July 29, 2014

Re: Friant Water Authority's comments on the Bay Delta
Conservation Plan and EIR/EIS.

Figure 24. Delta Outflow Change (Alt 4-ELT minus NAA-ELT)

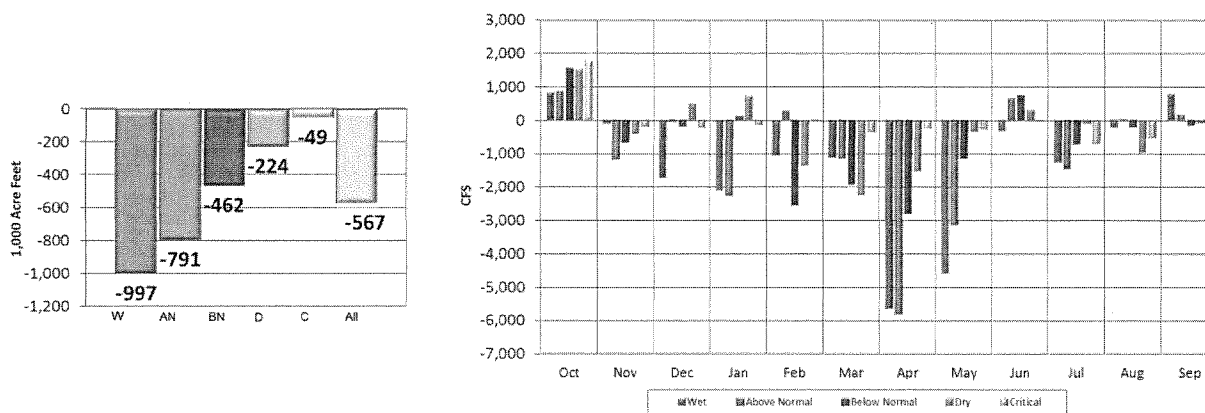
Figure 24 illustrates a comparison of Delta outflow between the NAA-ELT and Alt 4-ELT. Decreases in Delta outflow are the result of the CVP and SWP ability to increase Delta exports in Alt 4-ELT. The apparent increase in Delta outflow in October is partially due to additional export restrictions though Old and Middle River flow requirements. However, the increase in October Delta outflow is also due to an unrealistic operation of the Delta Cross Channel. The additional export restrictions cause the flow standards imposed at Rio Vista to be the controlling point in CVP and SWP operations; the water quality standards are all being met and do not require

flows above the amount needed to satisfy the Rio Vista standard. Meeting the Rio Vista flow standards without closing the Delta Cross Channel gate results in releasing more water from upstream reservoirs than would otherwise be necessary. This occurs because a certain amount of the water released to meet the Rio Vista flow standards would flow into the Central Delta at location of the Delta Cross Channel gate. This water would not make it to Rio Vista and therefore would not be counted towards meeting the Rio Vista flow standards. However, due to the BDCP model's assumed restrictions on exports at this time, this water could not be pumped from the South Delta facilities and thus ends up as "extra" Delta outflow. By closing the Delta Cross Channel gate, the operators would assure that all of the water released to meet the Rio Vista flow standards would be counted towards those standards. The BDCP model's assumptions that the Delta Cross Channel gate would not be closed are not practical or a sensible operation as the operators confirmed they would close the gate during these conditions to avoid the unnecessary loss of water supplies (as was done in October and November 2013). The assumption in the BDCP model to maintain the gate in the open position causes it to overstate the amount of Delta outflow.

Figure 60. NDD, and Sacramento River Flow

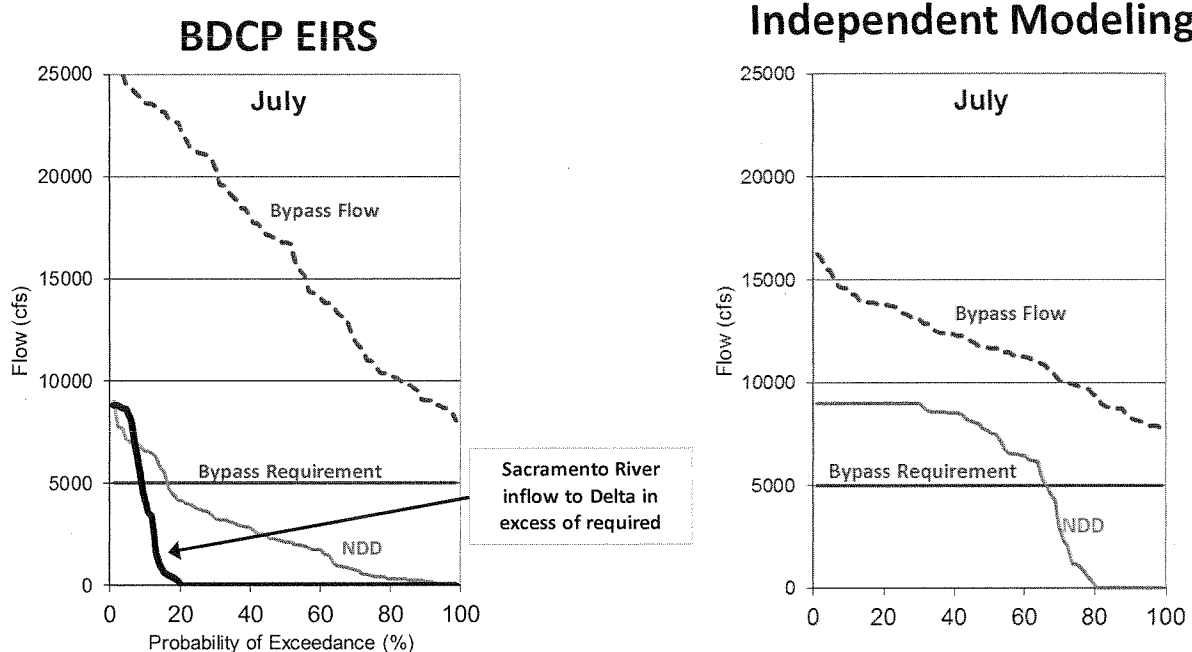
Independent modeling shows greater NDD during July and other months because the BDCP EIRS modeling includes artificially high Sacramento River bypass flow requirements. Figure 60 contains exceedance probability plots of Sacramento River required bypass, Sacramento River bypass flow, NDD, and excess Sacramento River flow to the Delta. As can be seen in Figure 60, bypass flow is always above the bypass requirement. The BDCP version of CalSim sets a requirement for Sacramento River inflow to the Delta that the independent modeling does not need in order to satisfy Delta requirements, therefore the NDD is higher in the independent modeling.

Figure 61. Sacramento River below Hood

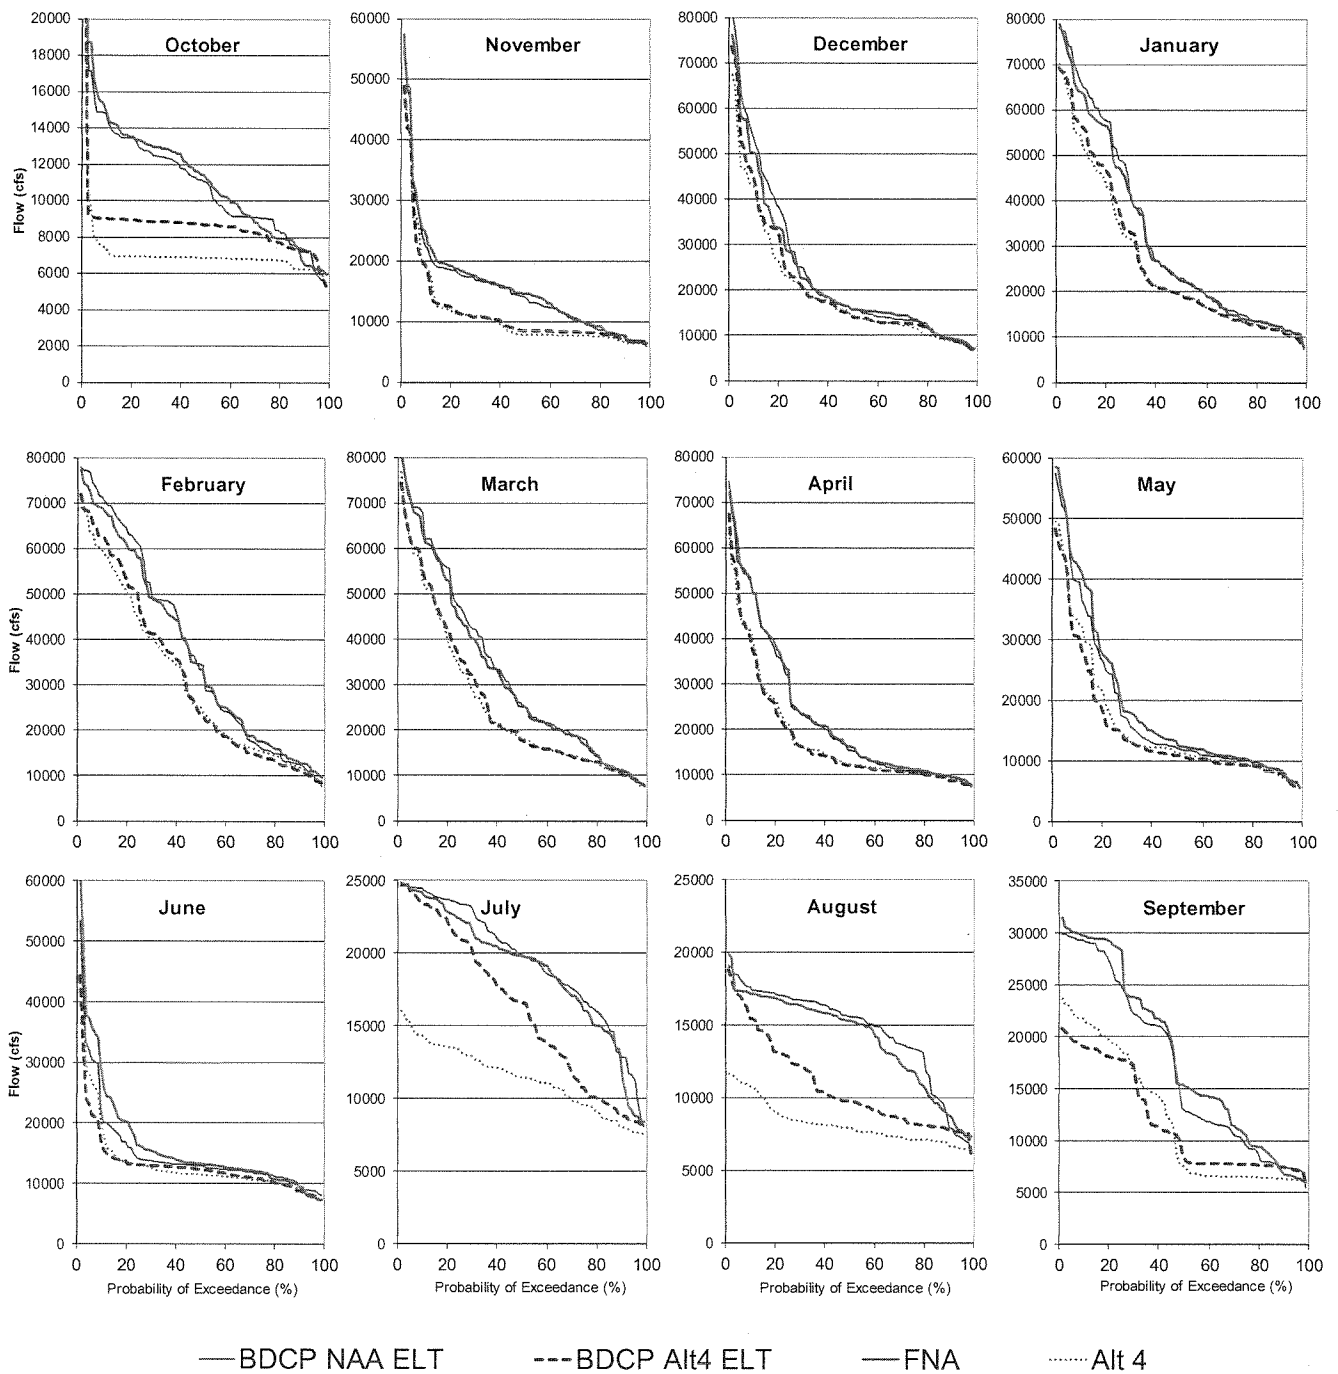
Figure 61 contains monthly exceedance probability plots for Sacramento River below the NDD for the following scenarios: 1) BDCP NAA-ELT, 2) BDCP Alt 4-ELT, 3) independent modeling FNA, and 4) independent modeling Alt 4. The most significant differences in flow changes occur in October, July, August, and September. Changes in Sacramento River flow entering the Delta are a key indicator of changes in interior Delta flows, water levels, and water quality.

In the independent modeling September flows are reduced by about 6,100 cfs while BDCP modeling shows a reduction of about 5,300 cfs. The independent modeling shows Sacramento River flow entering the Delta to be about 7,000 cfs 50% of the time, BDCP modeling show Sacramento River flow is about 8,000 cfs 50% of the time.
